# IAI WESTWIND

## SERVICE BULLETIN

1124 SERVICE BULLETIN INDEX

**DOUBLER INSTALLATION FRAME 194.00  
FIGURE 3**

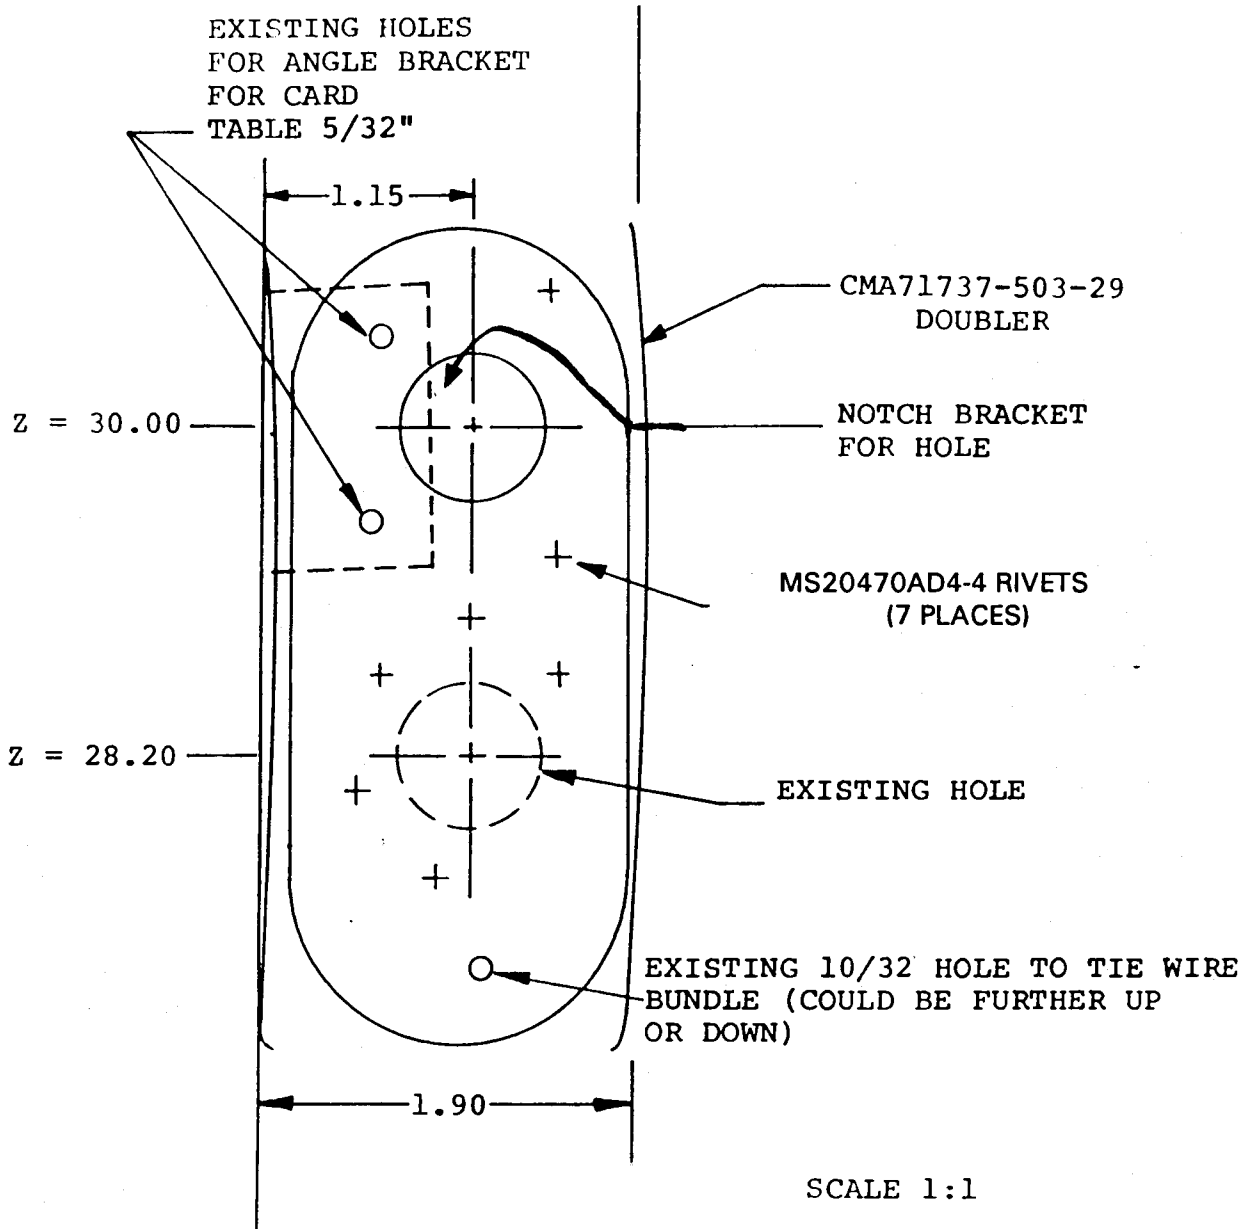
- (b) Doubler for frame at Sta. 194 must be of sufficient length to cover the existing hole at Z station 28.20. Refer to Figure 3.
  - (c) Install NAS1033-A3 nutplate on aft side of frames at Sta. 210.00 and 201.75 for Adel clamp to support tube.

FIGURE 1

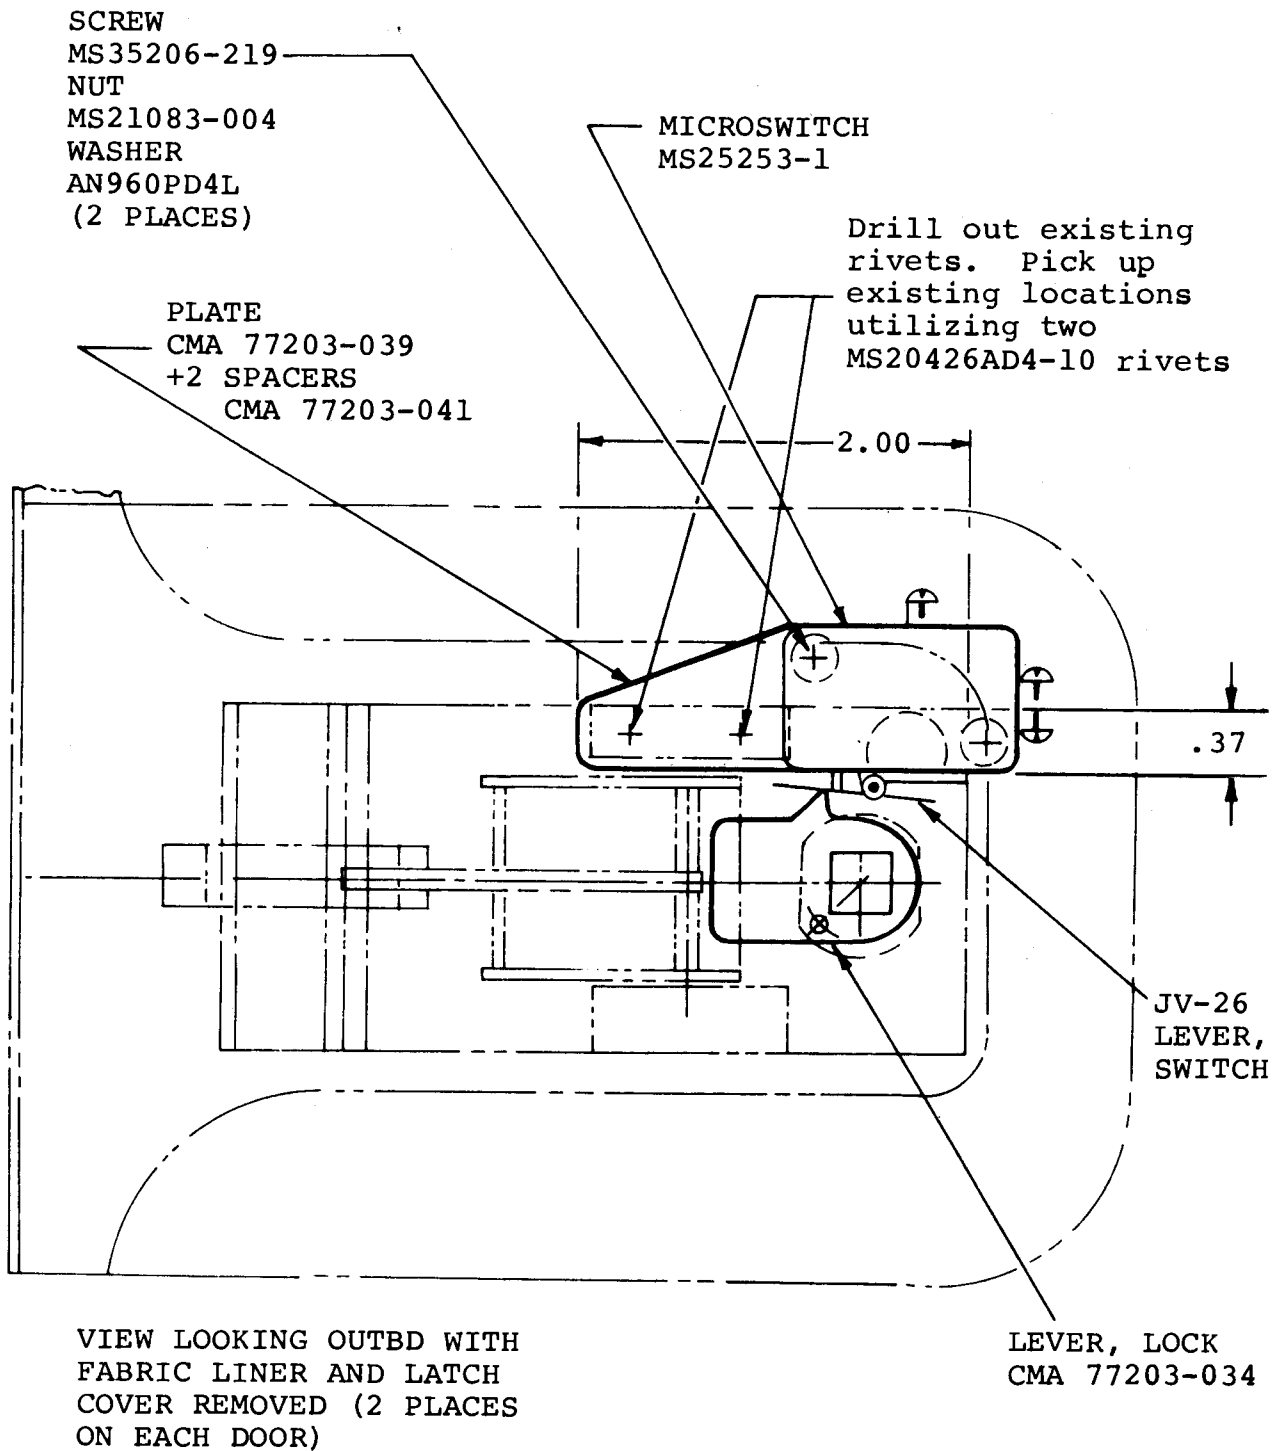
- F. Locate and drill two holes in the new CMA 77203-039 mounting plate as shown in Figure 1.
- G. Before installing the two new mounting plates, insert a CMA 77203-041 spacer in each of the existing counterbored holes in the upper hinge blocks. Install the new CMA 77203-039 mounting plates on the two upper hinge blocks (using existing rivet holes) and rivet in place utilizing MS2042AD4-10 rivets. (See Figure 2).

Figure 2

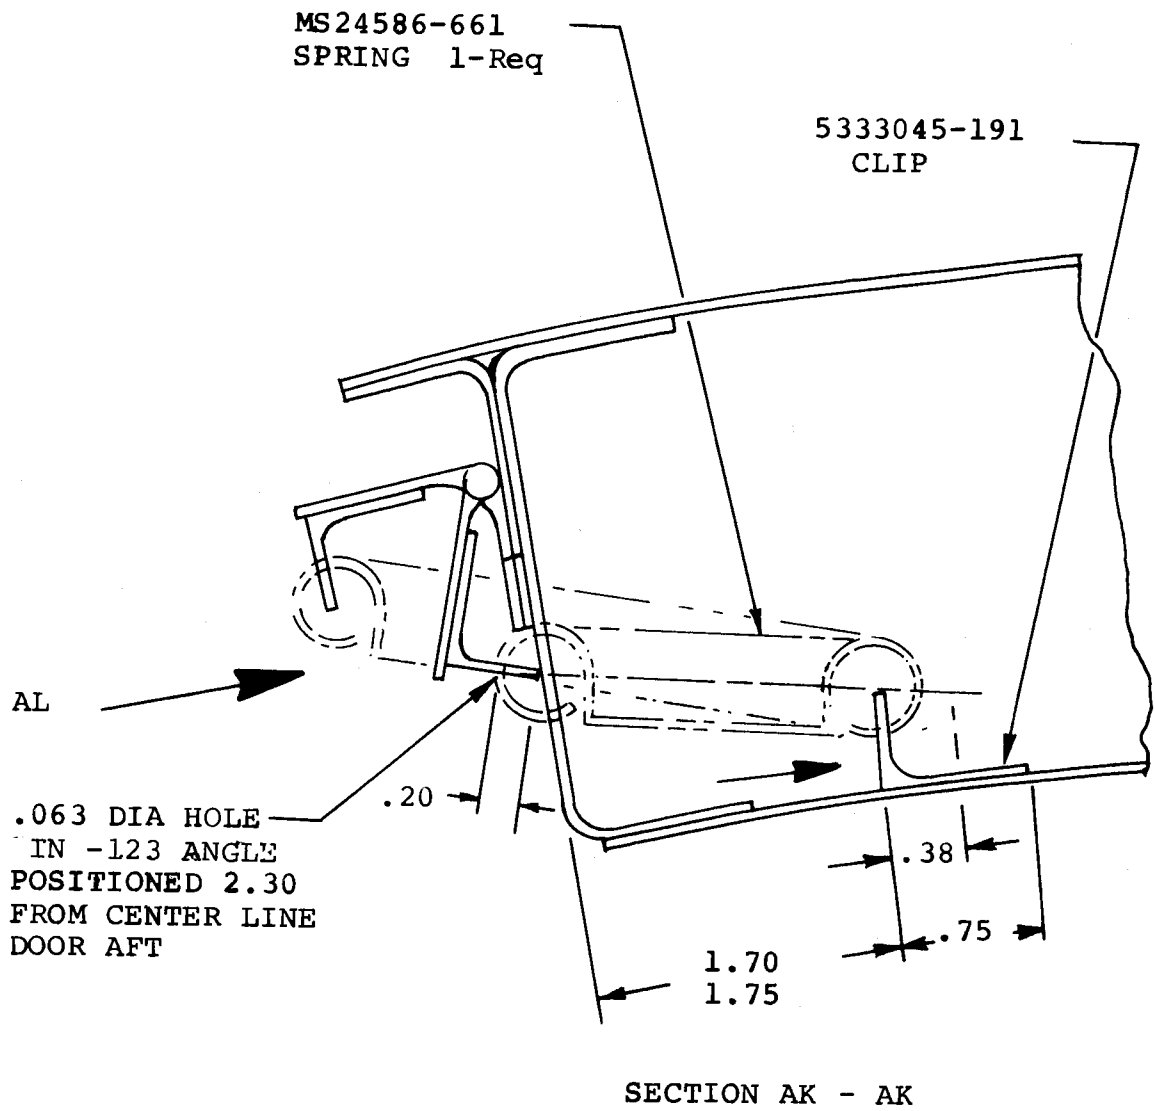
- A. Remove cabin door interior lining, including ice chest and bar if applicable.
- B. Using the measurements as outlined in Figure 3, locate and cut a hole in bottom door frame.
- C. Secure clip (5333045-191) by riveting (2 pls) to the inner door structure, using the dimension outlined in Figure 2 and Figure 3.

- D. Drill a .063 diameter hole in the flapper angle to align with the hole cut in the door frame (Step B) Refer to Figure 2 for dimensions.
- E. Attach spring to the clip and flapper angle. Check for sufficient clearance between spring and door structure.
- F. Reinstall cabin door interior which was removed in Step A.

FIGURE 1 DOOR-STAY EYE-BOLT RELOCATION

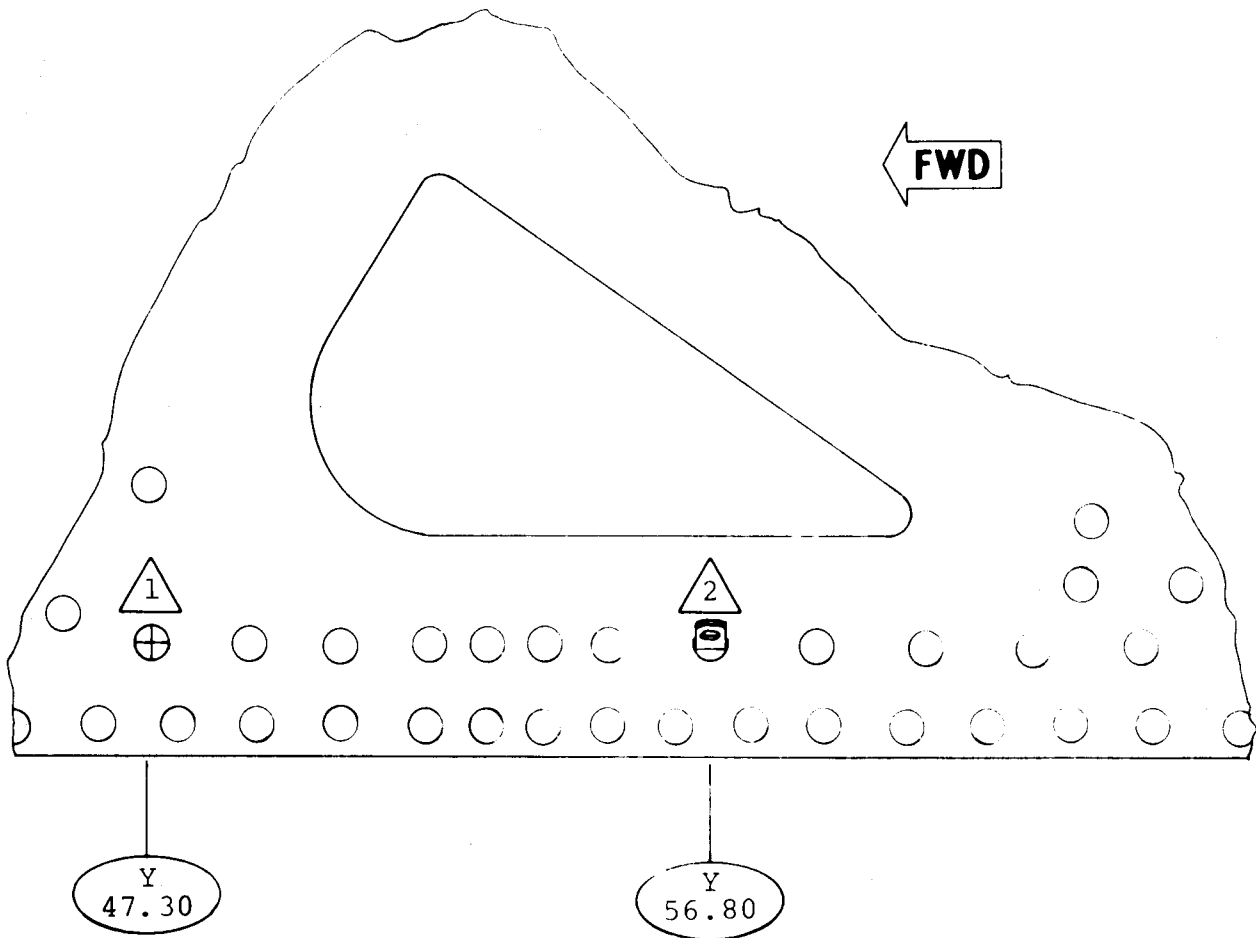
- A. Remove inside door trim panel.
- B. Remove pilot's seat and cockpit interior trim panel just below DV window.
- C. Move eye-bolt P/N 5123617-15 from its existing location to position shown in Figure 1. Plug old hole with screw removed to install eye-bolt in new location.
- D. Remove chain bushing P/N 5123617-13, reel assembly P/N 5123617-7, and bracket assembly 5123617-5 from entrance door and discard.
- E. Locate doubler P/N 5123617-RE3 per Figure 3 and drill eight #30 (.128 inch dia.) holes.
- F. With doubler secured in place, temporarily locate and drill 1.12 inch dia. hole through door and doubler. Ref. Figure 3.
- G. Slide door-stay assembly into door, locate and drill two #10 (.193 inch dia.) mounting holes.

1. REMOVE EYE BOLT P/N5123617-15 AND RELOCATE BETWEEN STATION Y-53.00 & Y-56.80 ACCORDING TO MAXIMUM OPEN POSITION. USE ONE OF EXISTING SCREWS LOCATED BETWEEN THESE STATIONS.

FIGURE 2 DOUBLER AND DOOR-STAY INSTALLATION

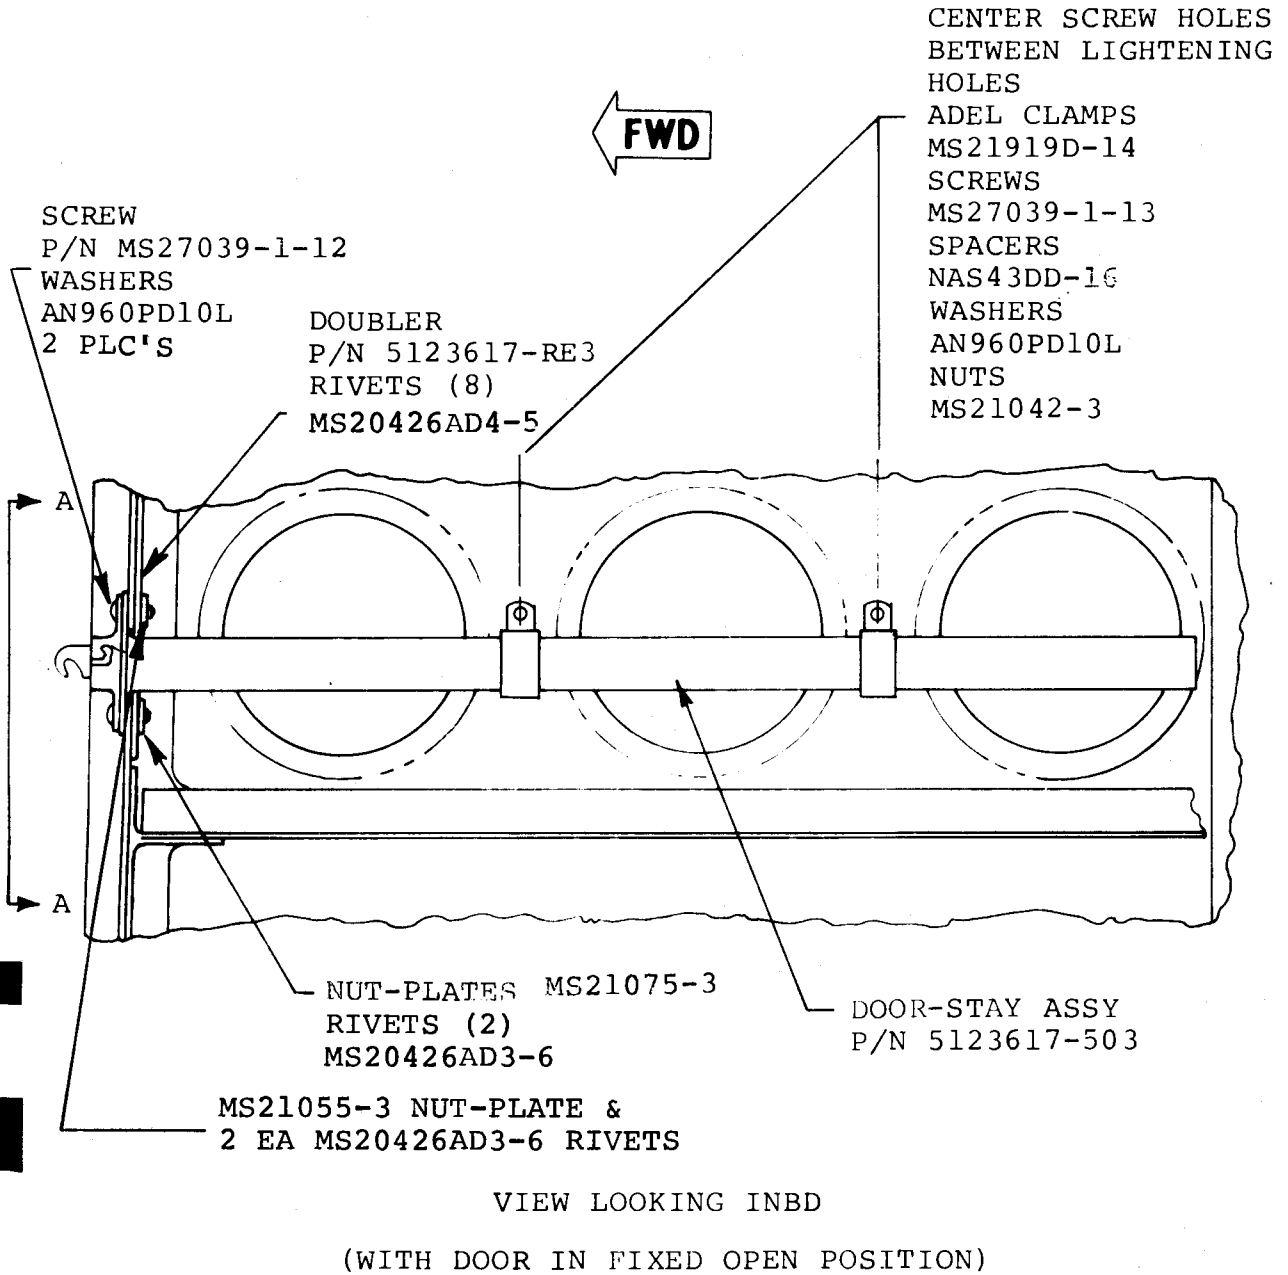
- M. Drill two #10 (.193 inch dia.) holes midway between lightening holes to secure Adel clamps. Ref. Figure 2.
- N. Install two MS21919DG-14 Adel clamps with MS27039-1-13 screws, NAS43DD-20 spacers, two AN960PD10L washers and MS21042-3 nuts, (supplied with door-stay Ass'y).

FIGURE 3 DOUBLE AND DOOR-STAY INSTALLATION

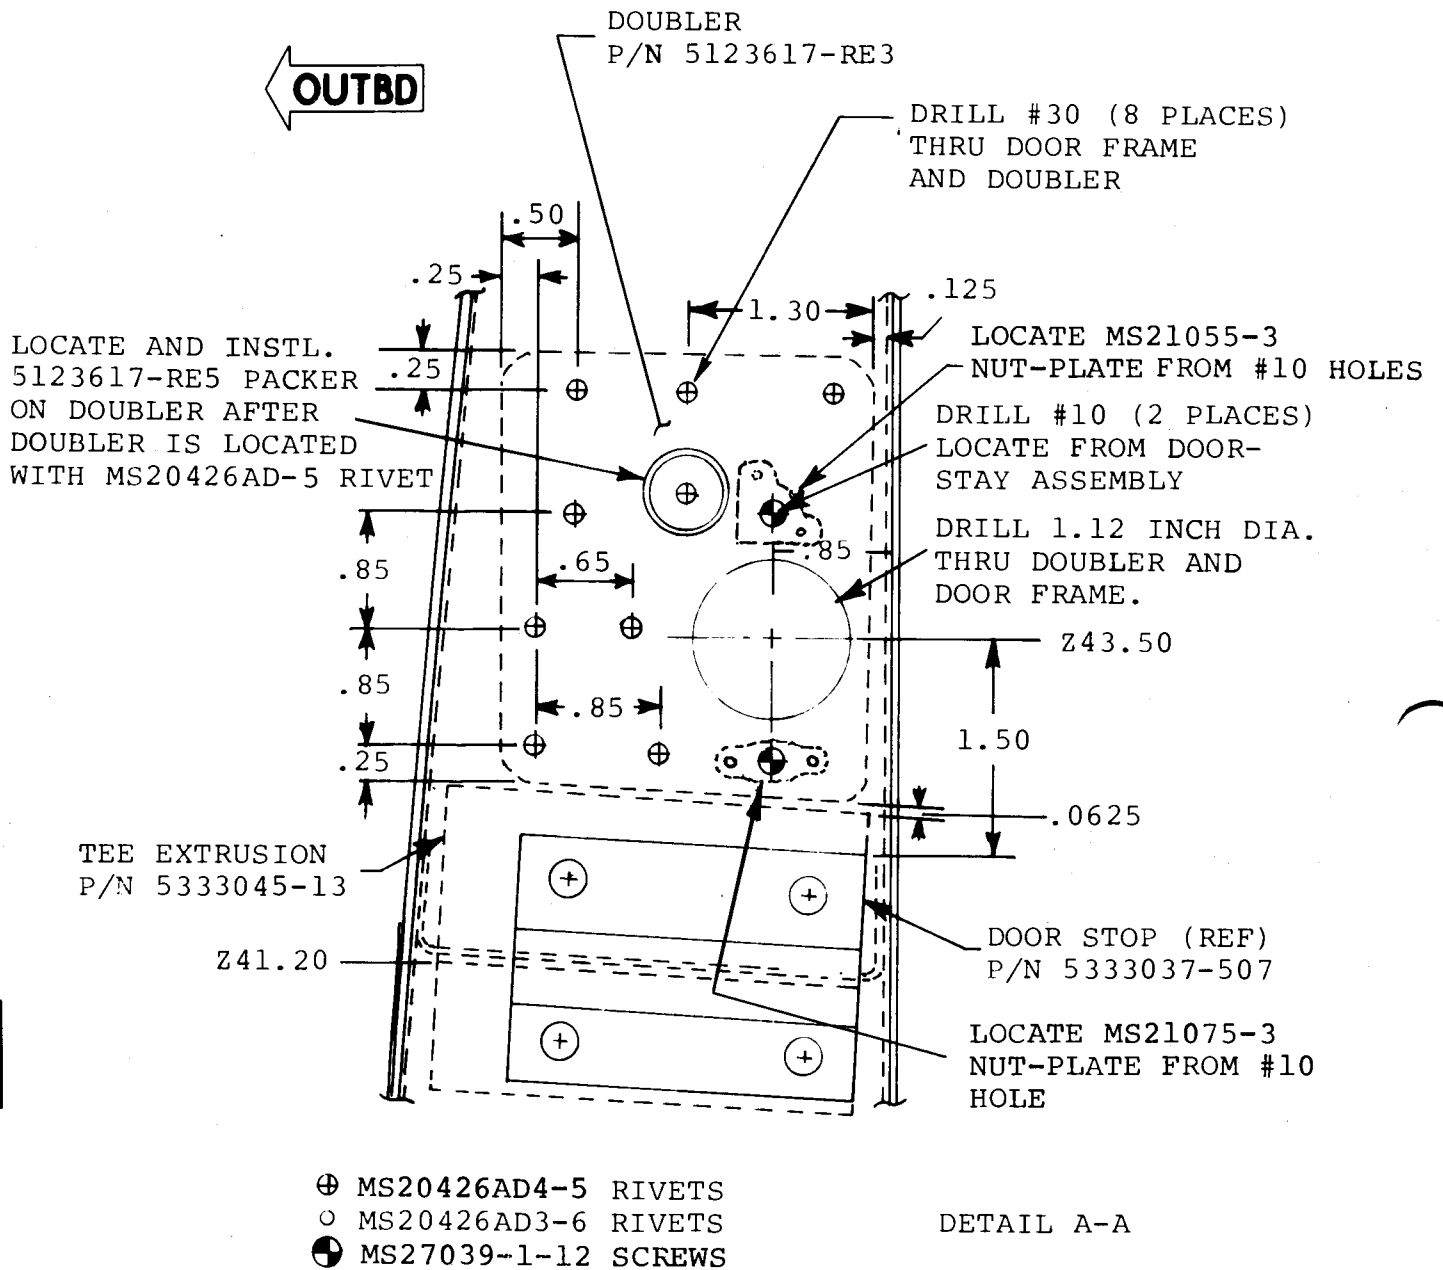
- H. Remove stay assembly, locate nut-plates and drill #40 (.098 inch dia.) holes for mounting nut-plates with four (4) MS20426AD3-6 rivets. Ref. figure 3.

INSTALLATION OF SCISSORS ASSY

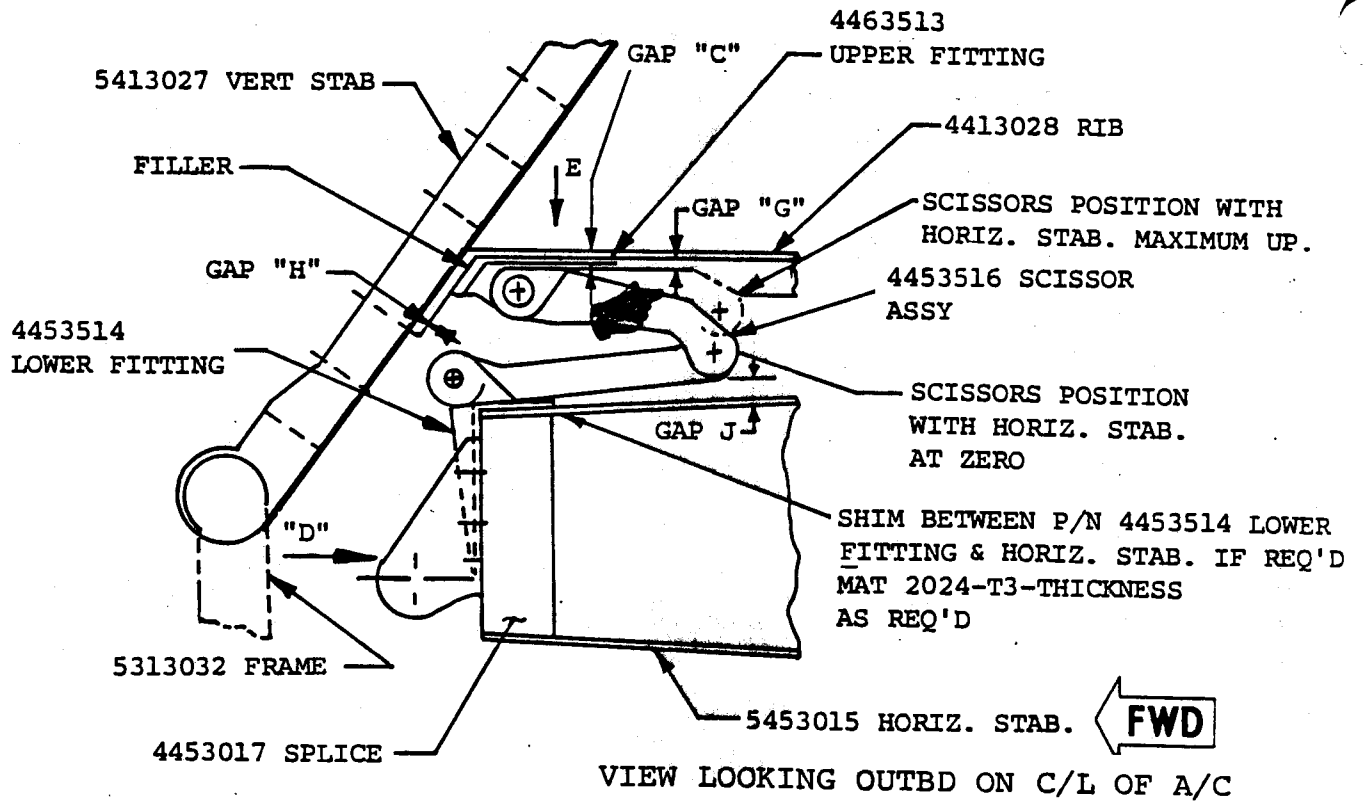
2.G.(1.7) Revised text in following paragraph to read as follows:

(page 19) If the reading of the dial indicator exceeds 0.010" on either lug, it is recommended to perform the improved installation as per Para. D.
